DA 26009707: 29 - 31 AUSTRAL TCE MORPHETTVILLE SA 5043 (BUPA)

**BUPA MORPHETVILLE REDEVELOPMENT
29-31 AUSTRAL TERRACE, MORPHETTVILLE
REQUEST FOR INFORMATION (APPLICATION ID 26009707)**

Figure 1 Waste Vehicle Swept Paths – Stage 1

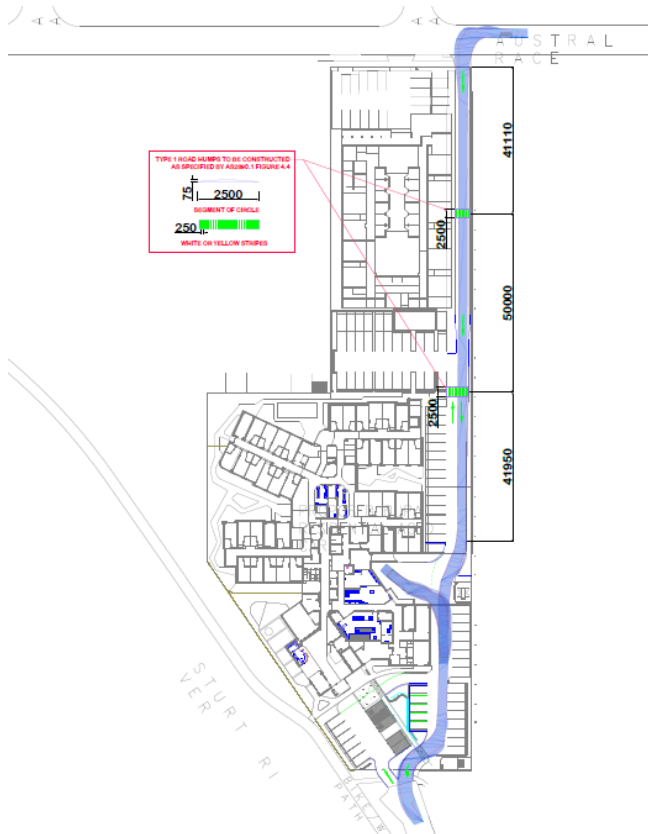
Council has also recommended that the applicant consider and identify the proposed collection route of waste collection vehicles in and out of the site and to demonstrate forward movement of collection vehicles, minimising reversing movements for safety.

Further clarification was also sought on the appropriateness of internal driveways being appropriately engineered and designed to accommodate repeated heavy collection vehicle use and for swept path and turning pressure point analysis.

The amended access points and internal driveway have been reviewed further by CIRQA and demonstrate the ability for a waste vehicle (10.2 metre rigid vehicle) to enter and exit the site in a forward direction.

Section 3.3 *Servicing and Deliveries* of the traffic and parking report specifies that the site will accommodate a 10.2 metre refuse collection vehicle (and other servicing trucks up to 11 metres) with all manoeuvres accommodated on site (forward-in/forward-out). Turn path plans for the waste collection vehicle during all stages of development are provided in Appendix B and highlighted in Figures 1 and 2 in the overleaf.

Figure 4 DPF 2.2 Complying Envelope

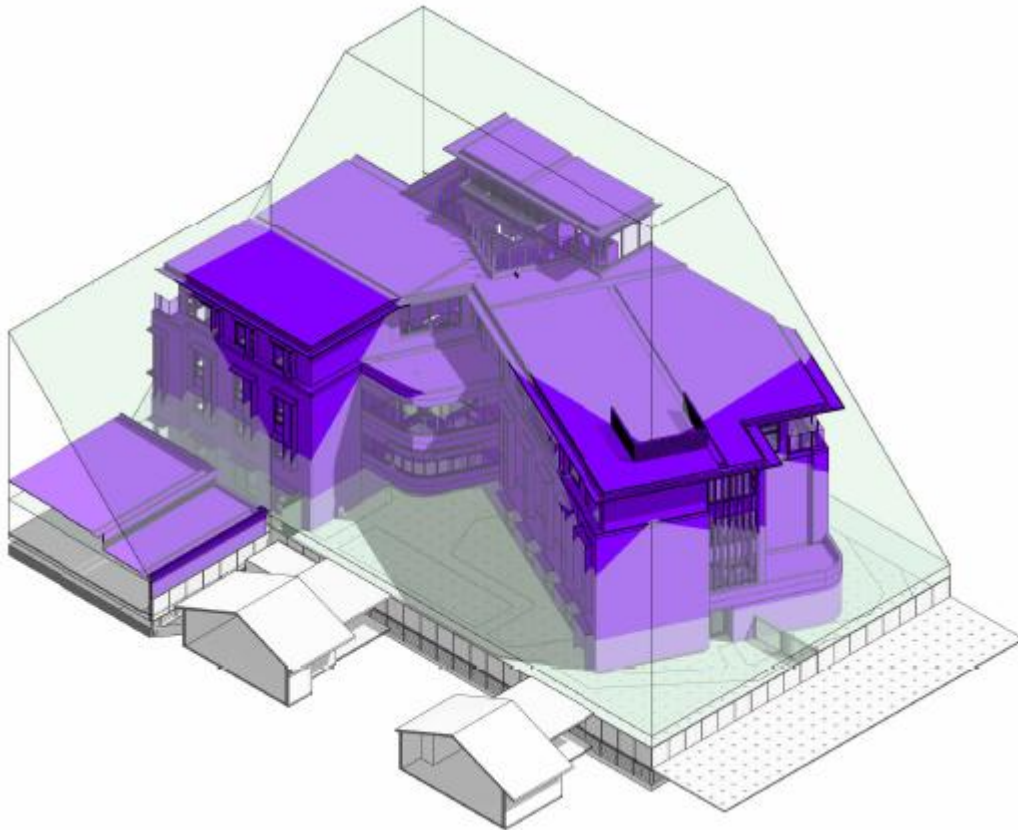
Design concerns raised by representors are directed at DTS/DPF 2.2 within the Significant Retirement Facility and Supported Accommodation Sites Overlay, with a focus on the northern boundary interface.

We acknowledge the representors have raised issues based on a location directly north of the proposed development site noting a portion of one of the 'fingers' exceeds the DPF guide.

In applying the 'numeric guide' of DPF 2.2, Figure 4 provides guidance on the extent of the area where the building achieves DPF 2.2, being the point where dark and light purple shading intersects.

Figure 4 likewise provides a visual depiction of where the building exceeds the numeric guide of DPF 2.2 with light purple shading.

It is also worth noting that the area depicted with light green shading highlights the large extent of area where no building work is proposed, however it would be within the DPF 2.2 guide.

- Significantly more building exceeds the guide offered by DPF 2.2 where adjacent the units to the NW;
- The 'fingers' offer significant articulation adjacent the units to the NW;
- The building purposefully provides setbacks that typically well exceed DPF 2.2 where adjacent the rear service areas (clothes lines), outbuildings and open space;
- Landscaped gardens adjoin the open space to the rear of the units at 25 Austral Terrace; and
- A single level carpark adjoins the open space to the rear of the units at 27 Austral Terrace.

Figure 5 Direct Overlooking – Level 1 and 2

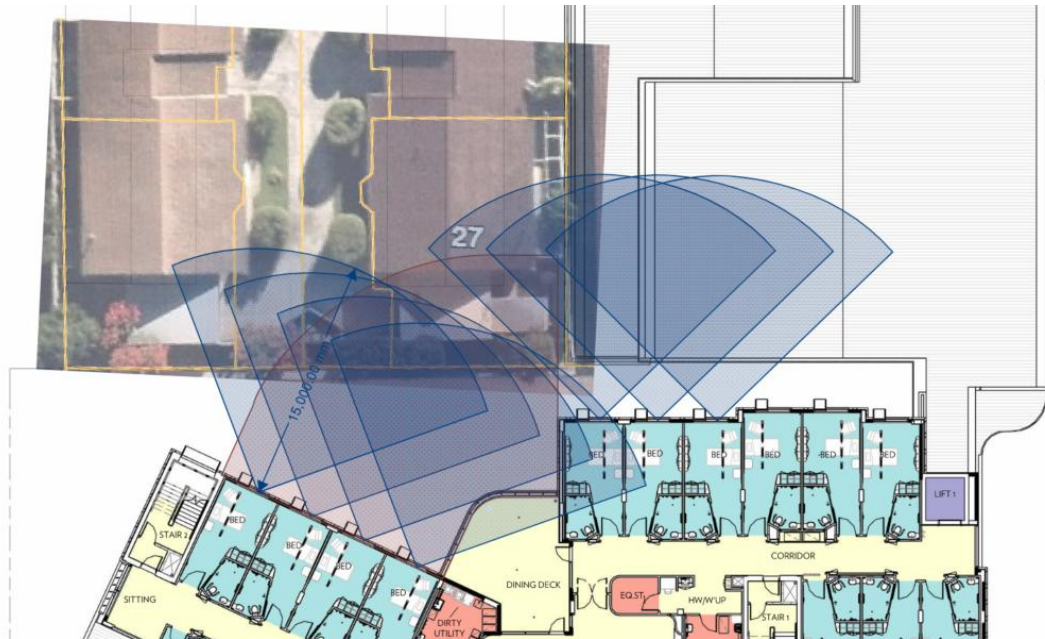
Figures 5 and 6 below demonstrates the extent of direct overlooking to the abutting northern properties. Upon a review of the of the area there is an existing carport and outbuilding, as well as clothesline in this location (refer Figure 7).

Excluding the area containing the carport and outbuilding, the extent of overlooking into what may be considered or used as private open space ('POS') is limited.

- Level 1 and 2:
 - » no direct overlooking from the windows associated with the NW finger will occur, with the outlook limited to the common driveway, carport and outbuilding structure.
 - » a small extent of overlooking is identified from the terrace 'dining' balcony (linking the NW finger and northern façade) and two (2) windows on the northern façade of the building for each level, however it is noted this area on the adjoining unit appears to be used as a service yard.
- Level 3:
 - » no direct overlooking from the NW finger windows will occur.
 - » no direct overlooking from the NW finger balconies will occur.
 - » views extend to the adjacent common driveway, carport and outbuilding structure.
 - » two (2) northern façade window present minor overlooking, however this appears to be associated with a service yard.
